1957 AMC-Hudson

Body Group &
Groups 1.000 thru 13.000

1957 - Body Section

POWER STEERING HOSE MOUNTING - "80" SERIES

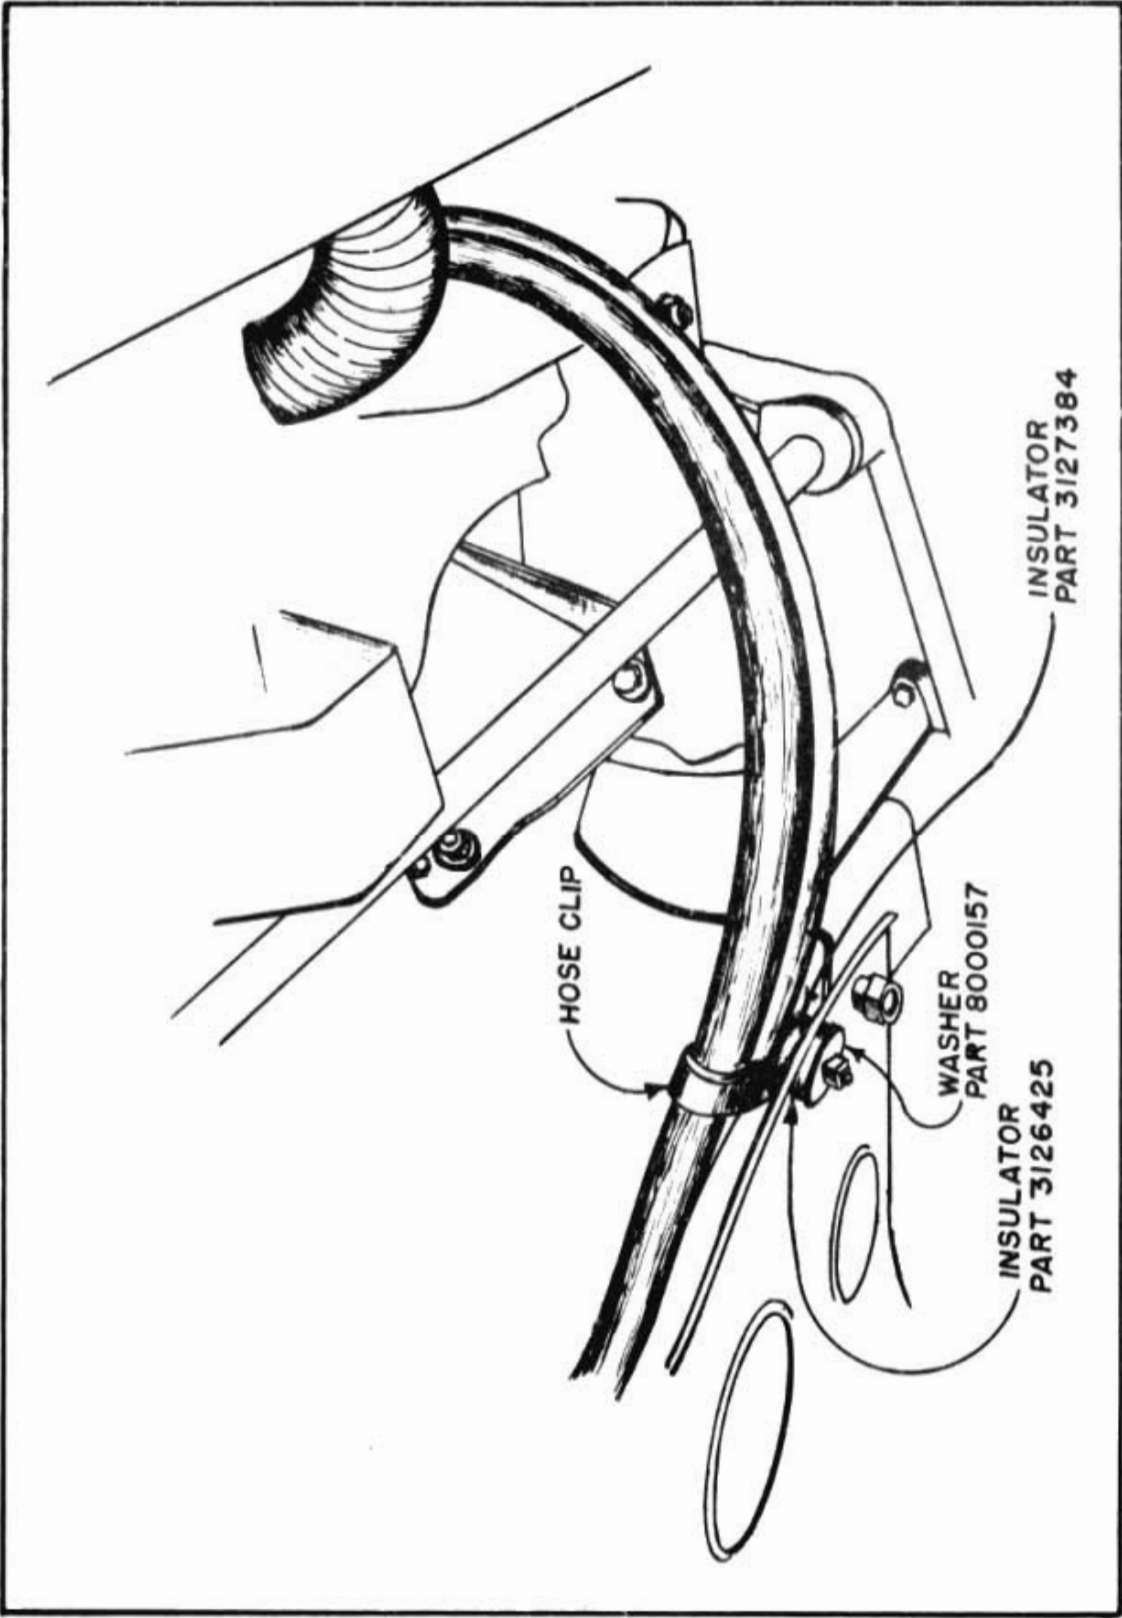
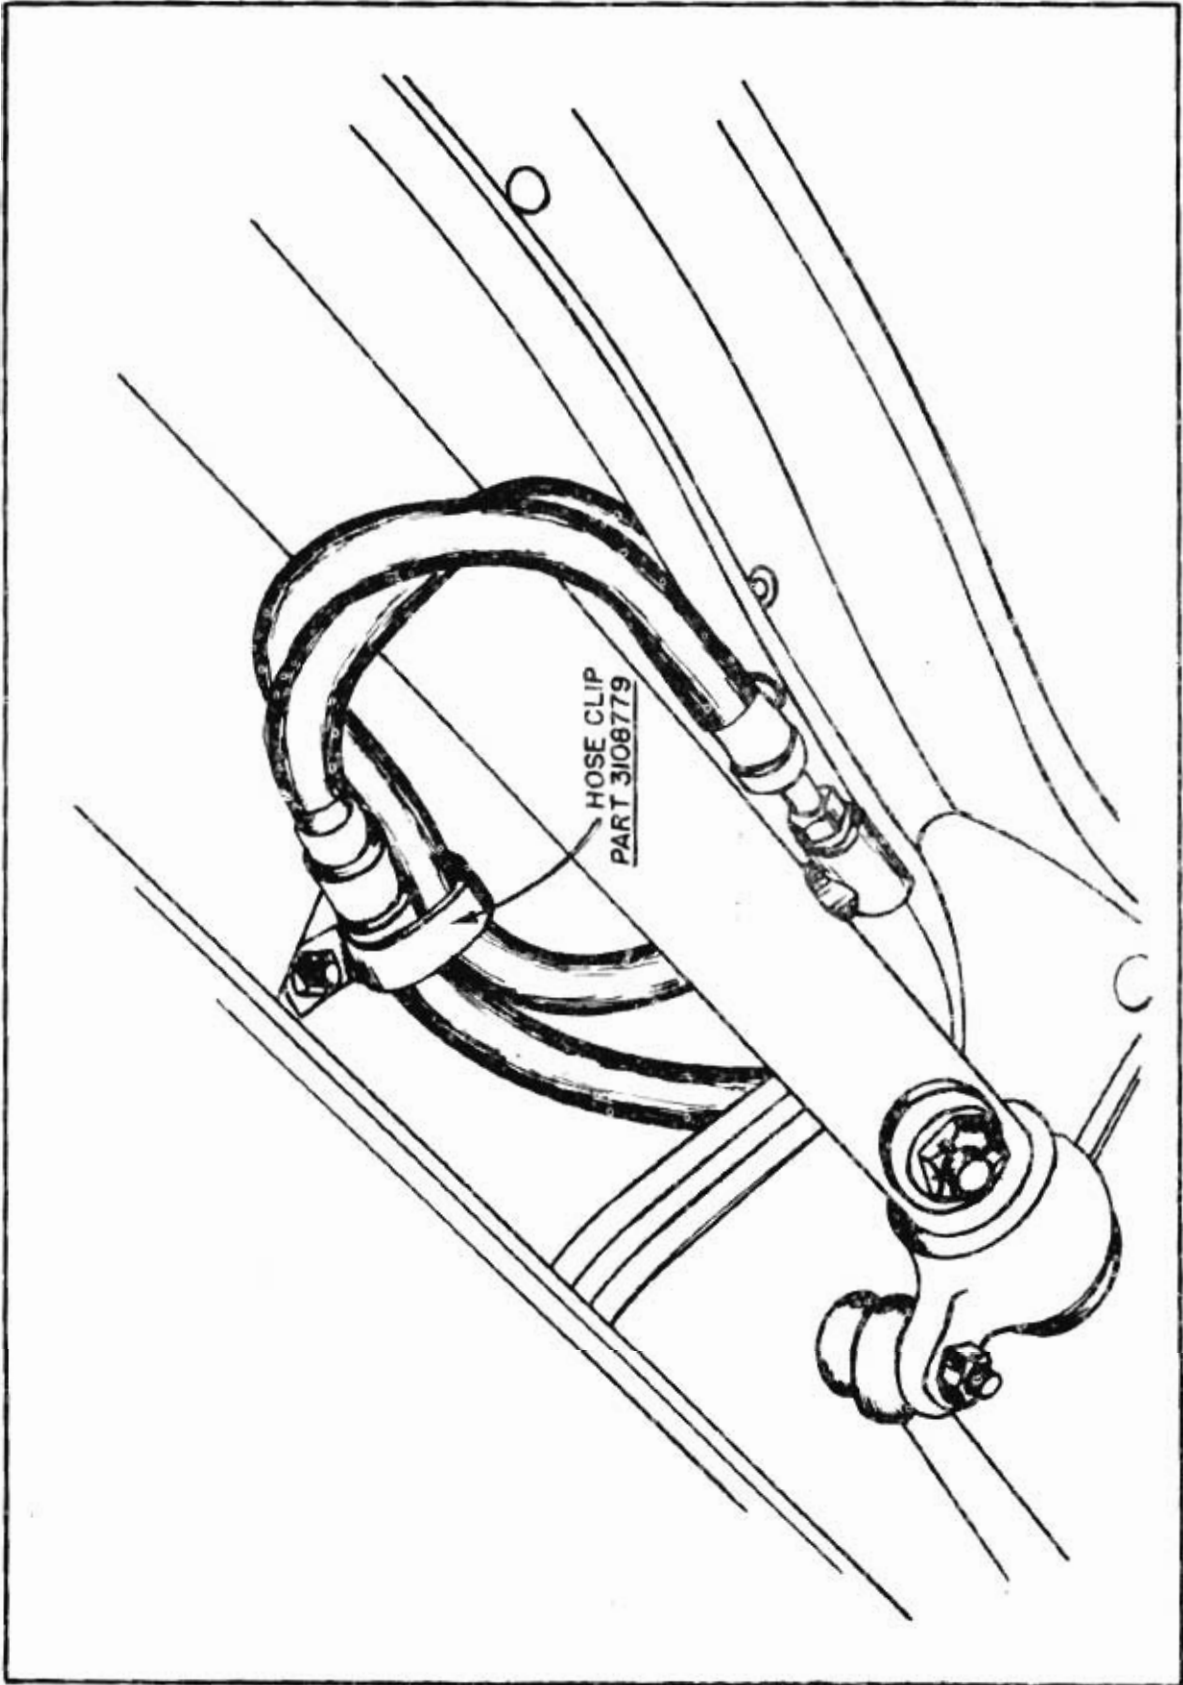
On the 5720 Series, the hose clip is removed from the front motor support cross-member and discarded together with the hose clip located on the oil pan stud.

The hoses are relocated under the power steering cylinder and retained with double hose clip, Part Number 3108779, mounted to the oil pan stud as illustrated in American Motors Technical Service Att. #57-3.

POWER CYLINDER SILL BRACKET BRACE ROD
TO ENGINE REAR SUPPORT CROSS-MEMBER
AT SIDE SILL - 1957 "80" SERIES

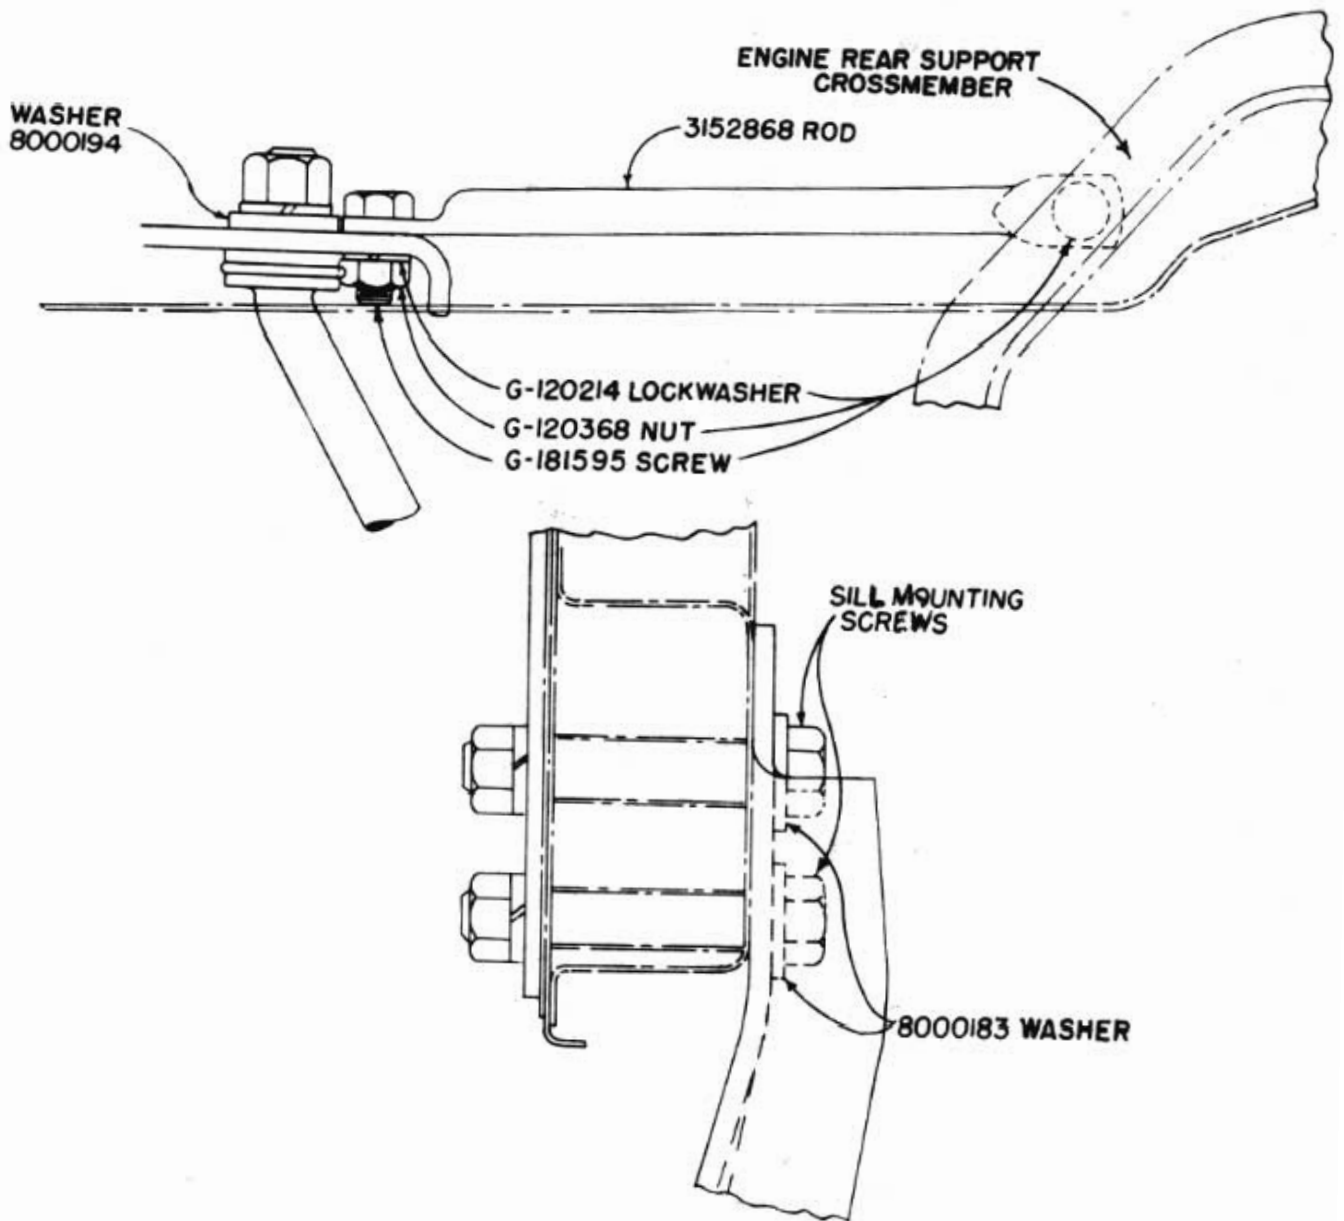
Effective at Car Serial Numbers V-24050 and Y-13525, a brace rod is being installed at the side sill, between the power cylinder sill bracket and engine rear support cross-member, to prevent possible movement of the bracket which may loosen the bracket screws under abnormal rough driving conditions.

American Motors Technical Service Att. #57-12 illustrates the mounting of the brace rod.
